## USB Version LMK4

USB version of the back panel

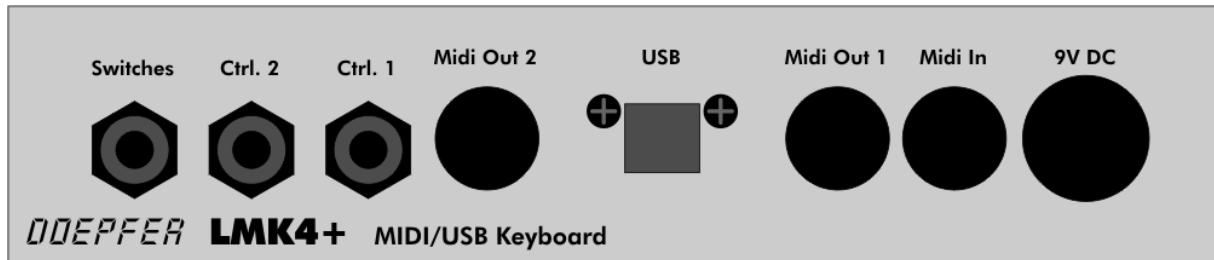
The new version of LMK4+ is equipped with an additional USB interface. Compared to the user's manual one of the two Midi Out 1 sockets and one of the two Midi Out 2 sockets have been replaced by an USB socket. This causes no significant limitation as the Midi out sockets of the former version were simply connected by pairs. The USB output transmits the same data as Midi Out 1 ("Midi over USB"). It is not possible to power the unit via USB because of the required supply current !
